**Subject: Comments on Draft EIR for Rancho Canada Village Specific Plan**

## Executive summary

Figure 2-5  
Existing Topography Boundary Map  
Vesting Tentative Map

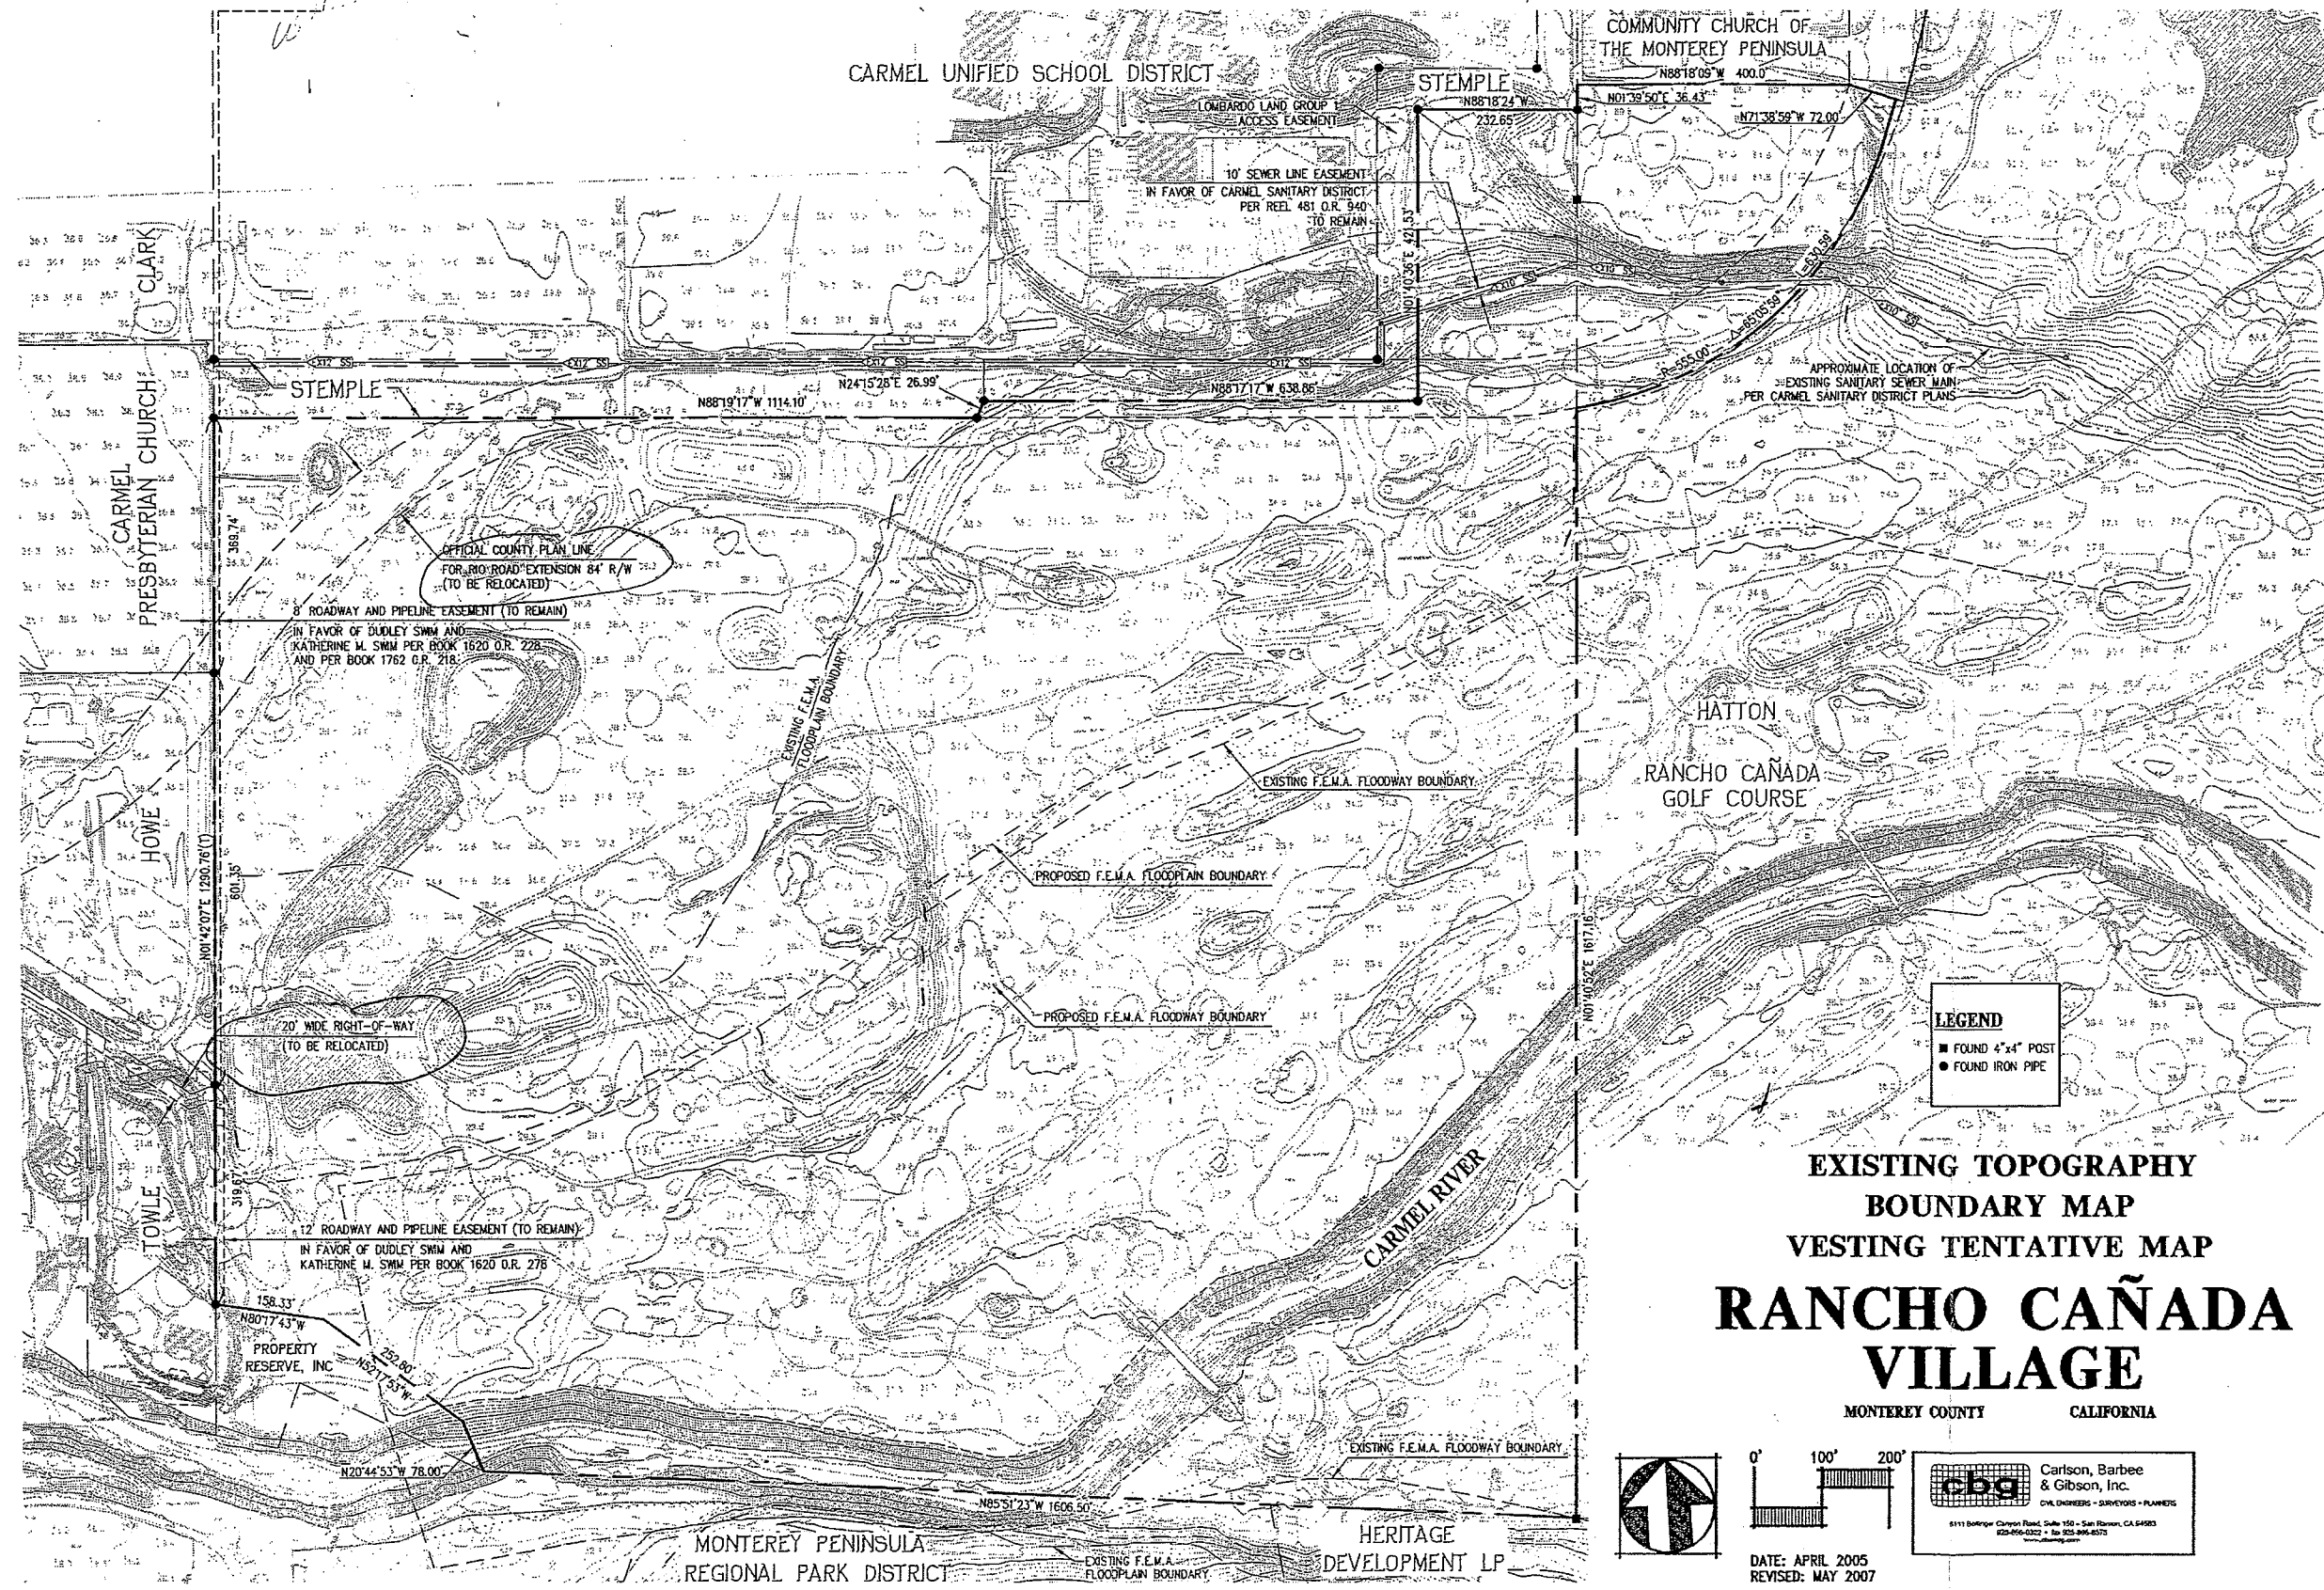
Figure 2.5 existing topography boundary map, vesting tenant map. Please explain in detail what County policy allows the applicant at his whim to relocate an existing official county plan line for the Rio Road Extension. And further explain in detail exactly where the applicants will relocate the official county plan. Please explain in detail why this relocation has not been analyzed in this DEIR. Finally, please explain where the 20' right of right away will relocate and why the impacts of this relocation on neighboring properties has not been analyzed. (See DEIR 1 with yellow highlights.)

Figure 3.4-8  
Views of Rancho Cañada from Carmel Valley Road

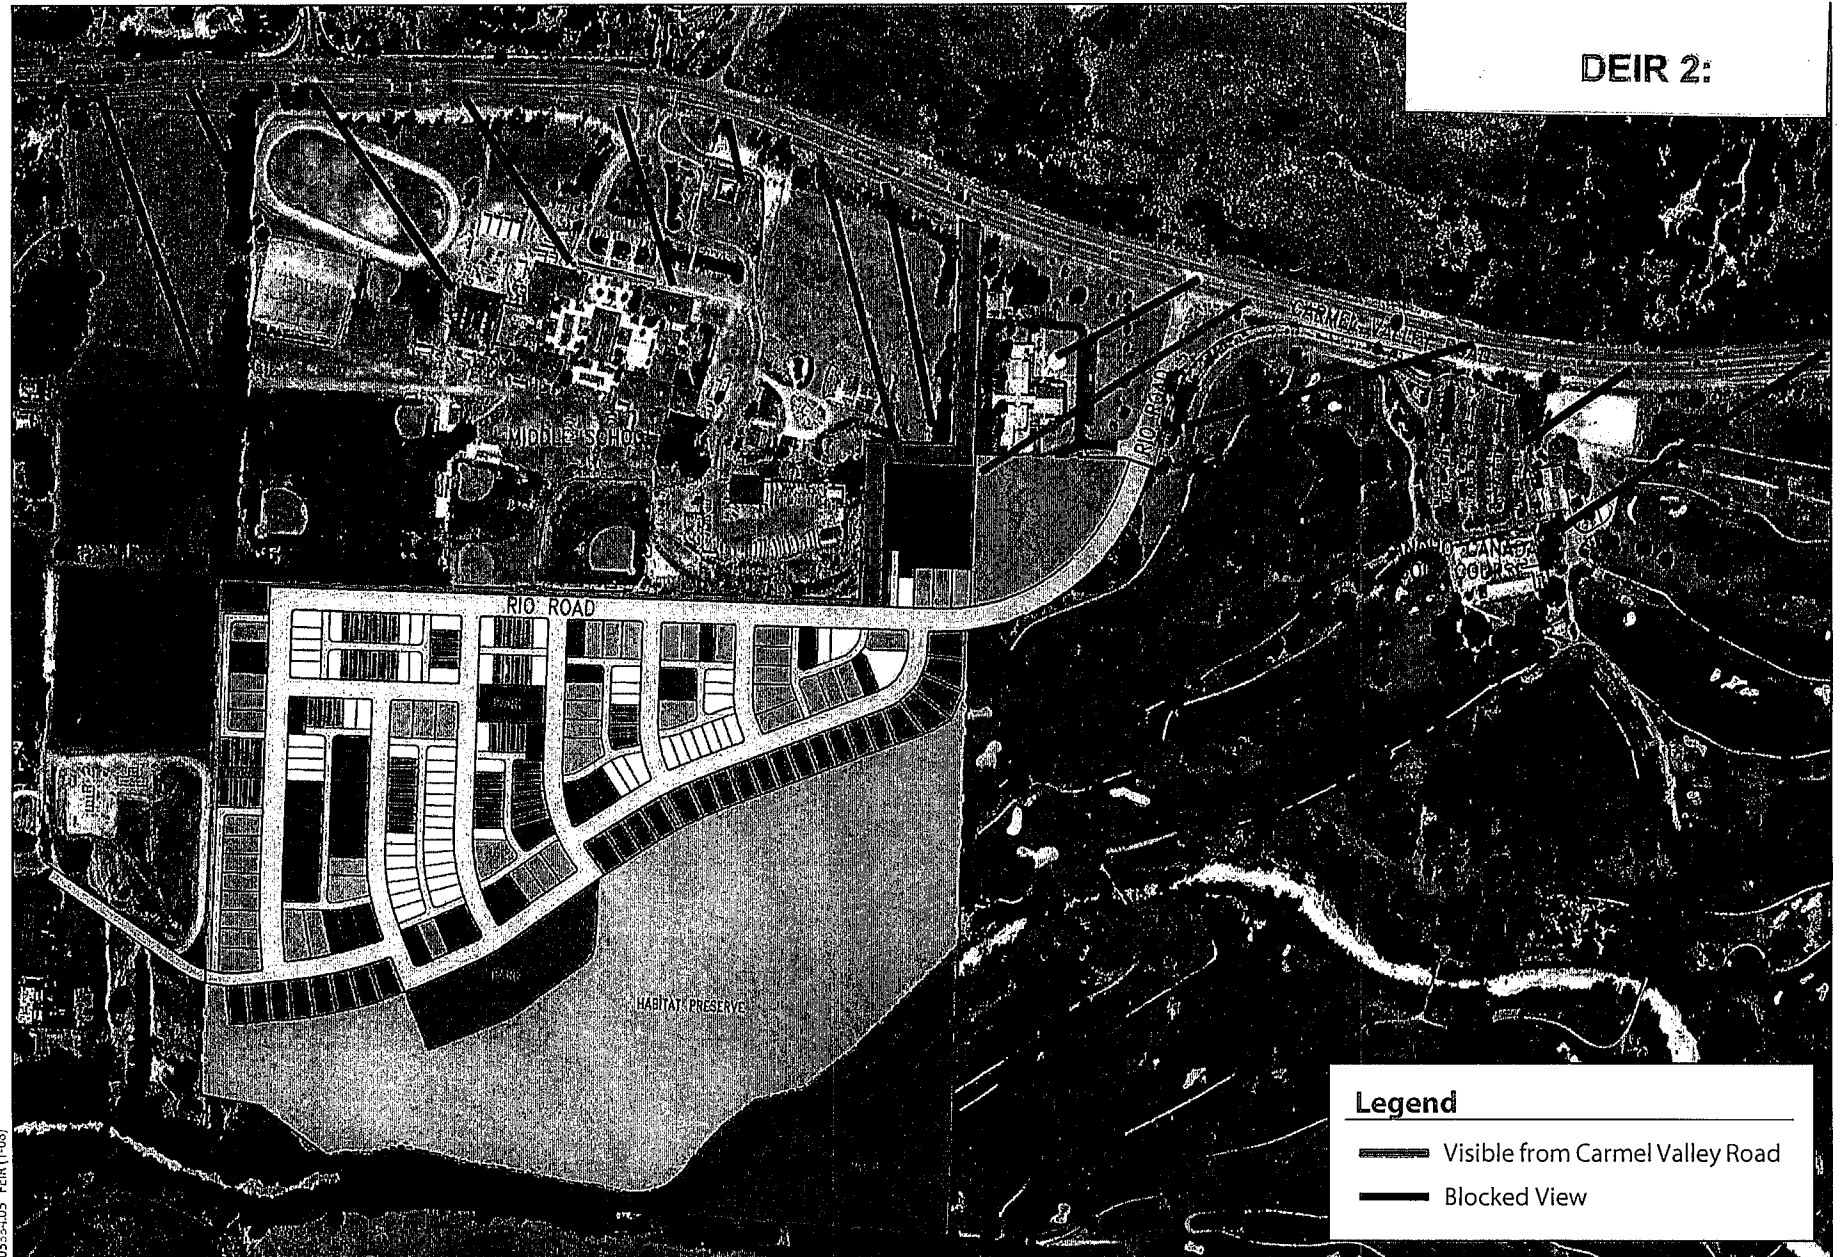
In light of Exhibits C through L, please explain how DEIR 2 provides a complete and realistic representation of the visibility from Rancho Canada Village.

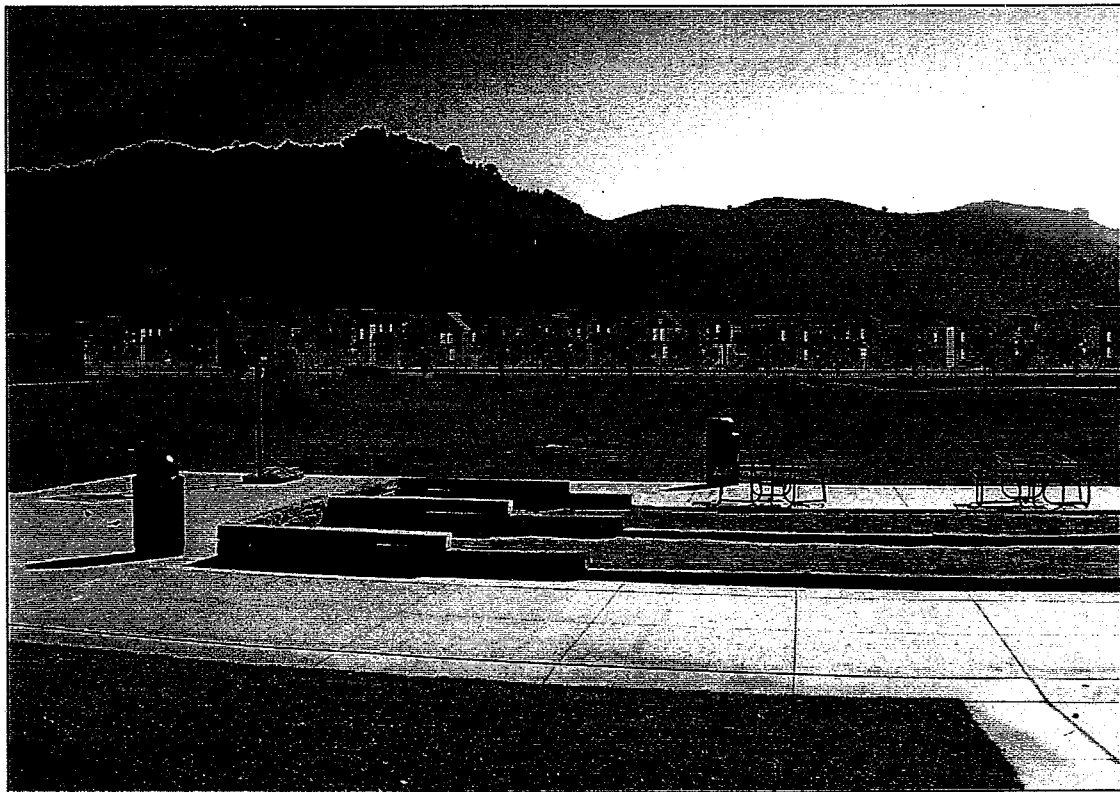
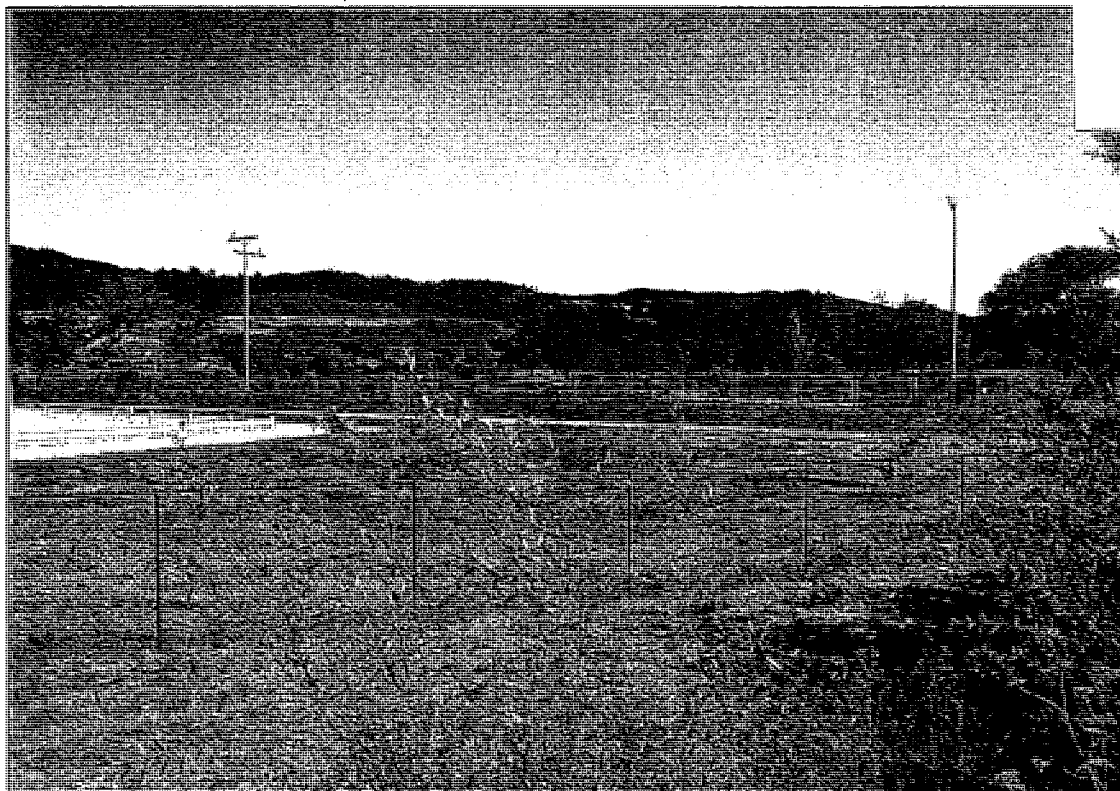
31. Figure 3.4-7 The visual simulation appears to show the following: (1) a wide planting strip, (2) a raised and should also show a road before the units. Please indicate exactly where I can find a map that shows these items. How many feet from the fence line are the buildings in Rancho Canada Village located? Please explain how the visual screening shown in this figure be considered adequate screening. Please explain why this simulation is said to be taken from Rio Road when it is obviously taken from the Howe property. (Compare to Exhibit I)
